April 25, 2022

Mr. Koko Tomassian
Program Manager, Compliance Assurance Division
Office of Energy Infrastructure Safety
715 P Street, 20th Floor
Sacramento, CA 95814

Reference: Energy Safety Record ID: NOD_MJ4_PGE_20211207_01
Notice of Defect: Government Code § 15475.2 and the California Code of Regulations, Title
14, Section 29302(b)(1)

This letter is in response to the March 11, 2022, Office of Energy Infrastructure Safety (Energy Safety) Notice of Defect (NOD) from an inspection occurring on December 7, 2021, of grid topology improvements and system hardening work in Santa Cruz, Santa Cruz County. The NOD alleges two (2) types of defects which include vegetation contacting the guy wire above the insulator and excessive splicing in a single span.

Defect 1: Pole 120784771

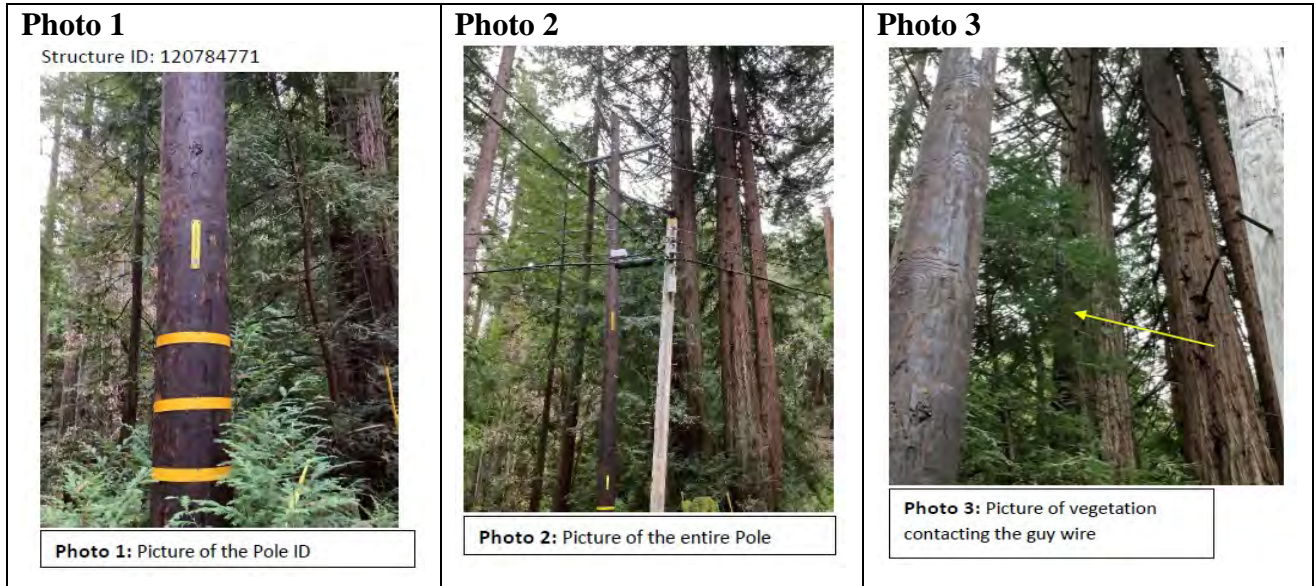
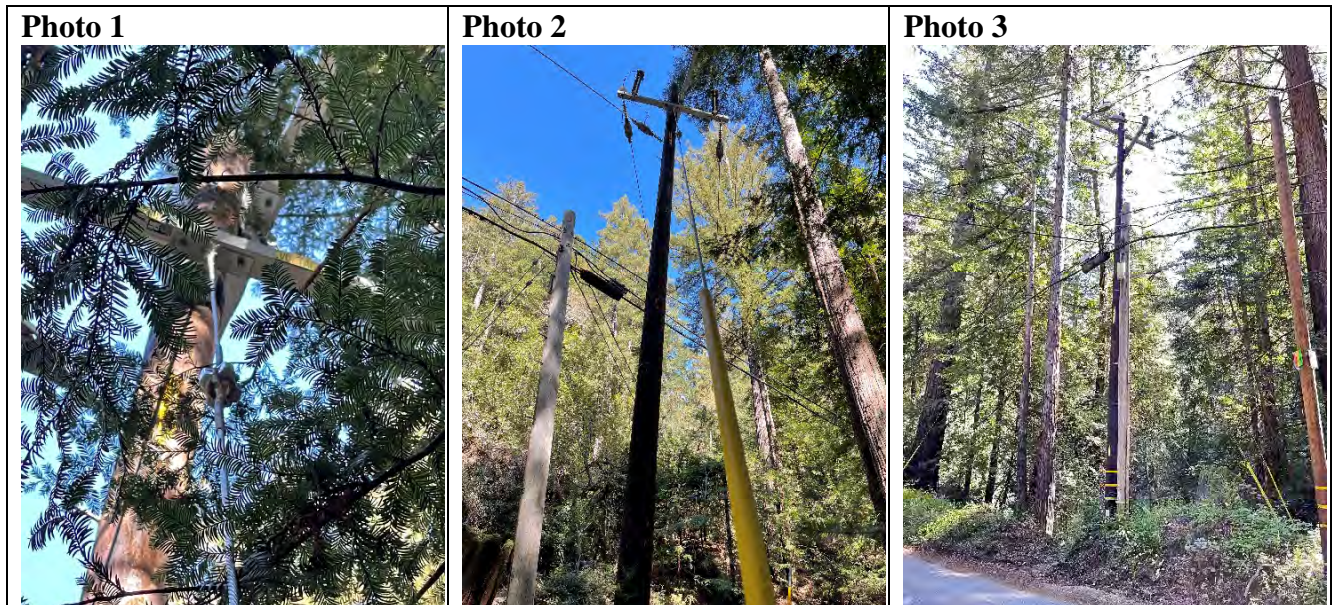
Regarding Defect 1, pole 120784771, vegetation contacting guy wire above the insulator, we agree with the finding. On March 23, 2022, we performed a field inspection and observed minimal new vegetation growth contacting the guy wire above the insulator. The vegetation was trimmed on the same day of the field visit; please see Attachment 1 for photos.

Disposition: Agree with Defect Finding - Vegetation contacting the guy wire above the insulator.
